Access Compliance Report

Public Rights-of-Way

(Curb Ramps)

| Intersection ID: 16008 | Main Street: SEDGEFIELD RD | Cross Street: WRISTON_PL | Location: SE |

| ADA ID: F2A54B7155E7 | Ramp Type: Directional1 | Initial Pass/Fail: Fail | Overall Compliance: No |

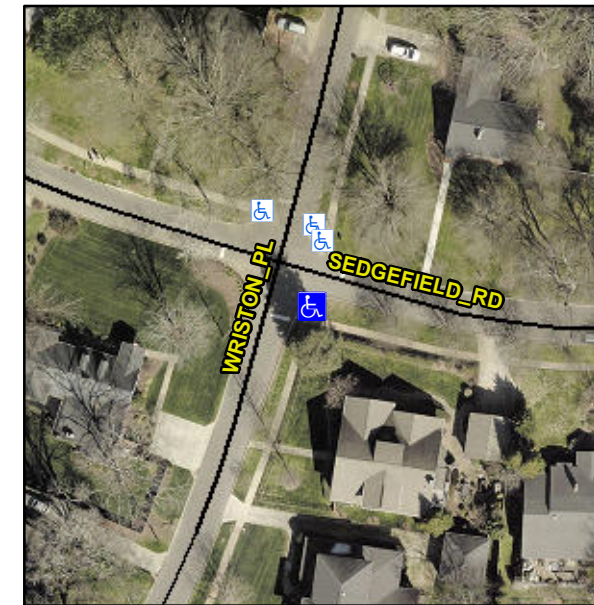
Surveyor Notes:

CURB LIP 1.0"

PROW/ADA:

R304.5.1, R304.5.3

| Compliance | Description | Data | Compliance | Description | Data |
|------------|-----------------------|------|------------|-----------------------------|------|
| No | Ramp Width (in) | 44.0 | N/A | Grade Break Slope (%) | 0.0 |
| No | Ramp XSlope (%) | 2.5 | | | |

Possible Solutions:

Remove & Replace Entire Ramp.
